To: Michael Saieed, AIA
From: Jeff Walton, Associate Planner; 910-341-3260
CC: File;
Date: 4/2/2015
Re: Pantana Bobs Planning Comments

Proposed Existing Facility Alteration for Pantana Bob's
 149 SOUTH COLLEGE ROAD
 WILMINGTON, NORTH CAROLINA
SITE LANDSCAPE PLAN
 Contract Documents - Issued for Construction

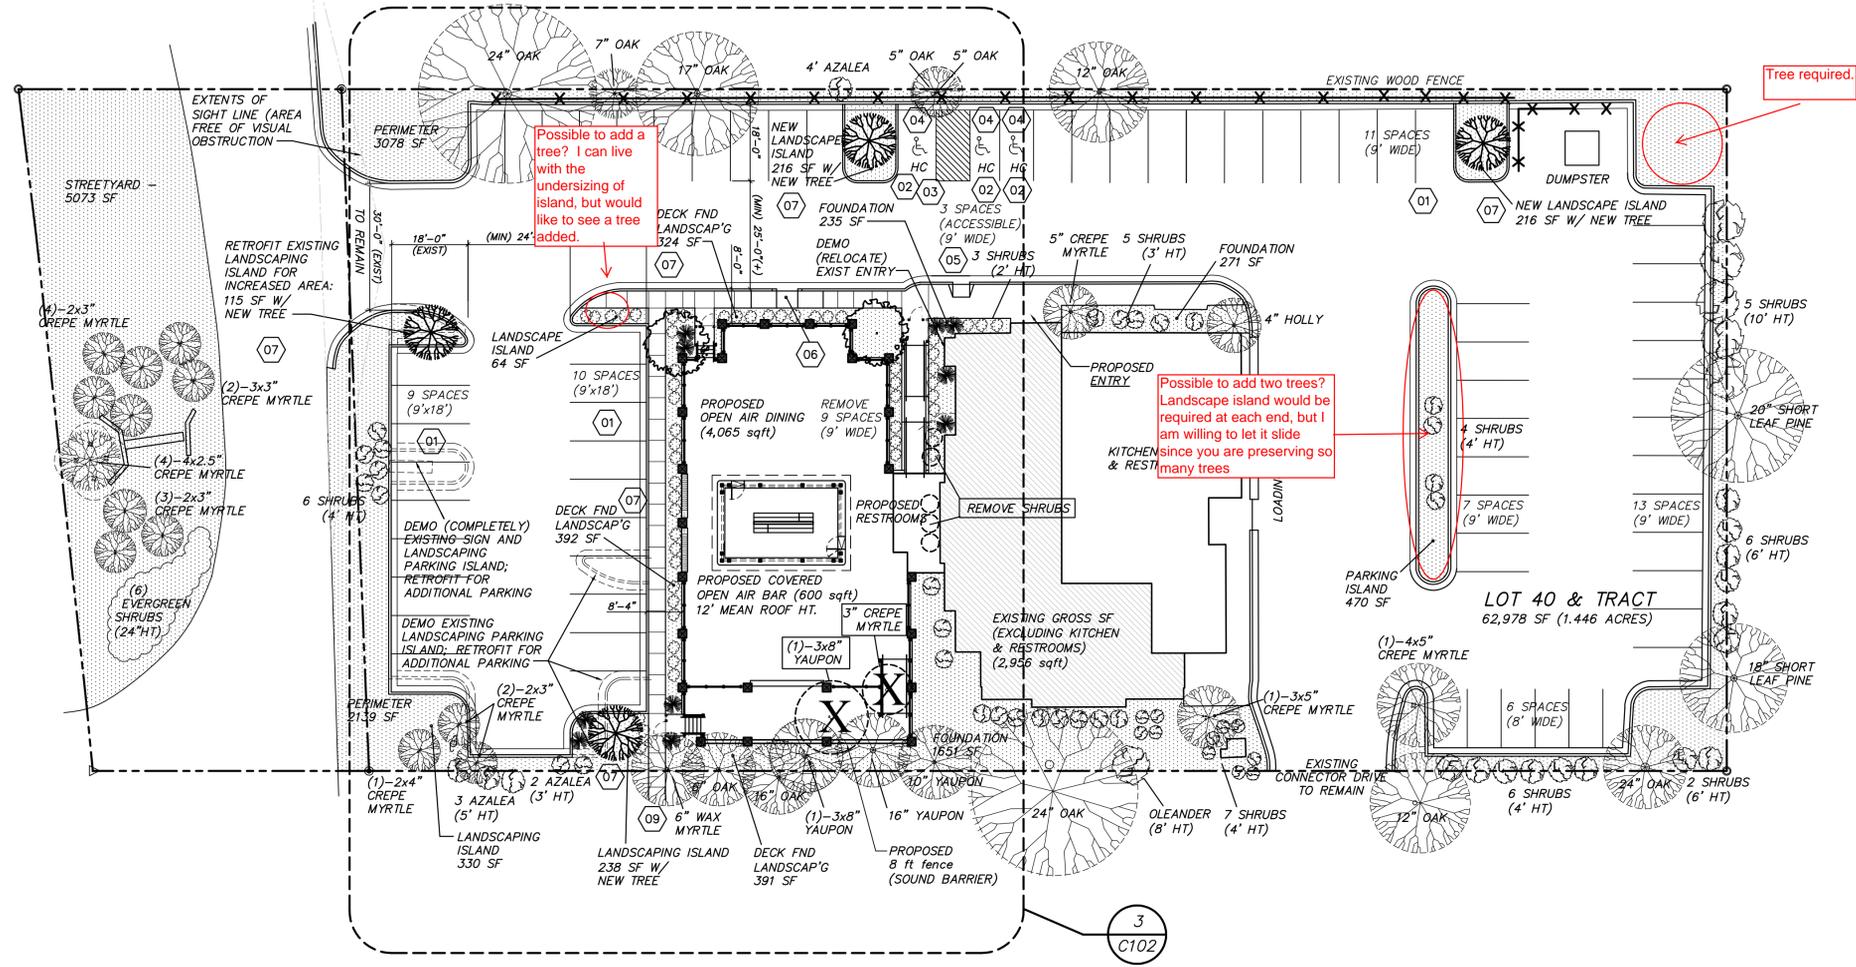
- Sec. 18-60 (c) (11): Show location and dimension of all fencing and screening.
 - Show type, height and gate detail for improvements to the dumpster pad.

- Show bicycle parking compliance. Each new commercial or office development requiring 25 or more auto parking spaces shall make provisions for parking a minimum of 5 bicycles.

- A tree preservation/removal permit is required
 - Show tree protection fencing around preserved trees.
 - Add detail sheet for tree protection fencing.

LANDSCAPE PLAN SCALE: 1" = 20'-0"

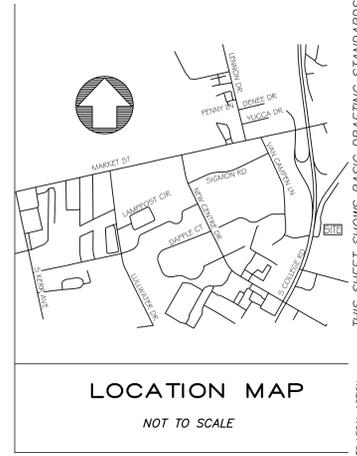
- Sec. 18-462 (d) (4): Show note on plan stating that prior to any clearing, grading, or construction activity, tree protection fencing will be installed around protected trees or groves of trees. And no construction workers, tools, materials or vehicles are permitted within the tree protection fencing.
- I attached a redline of additional trees required.
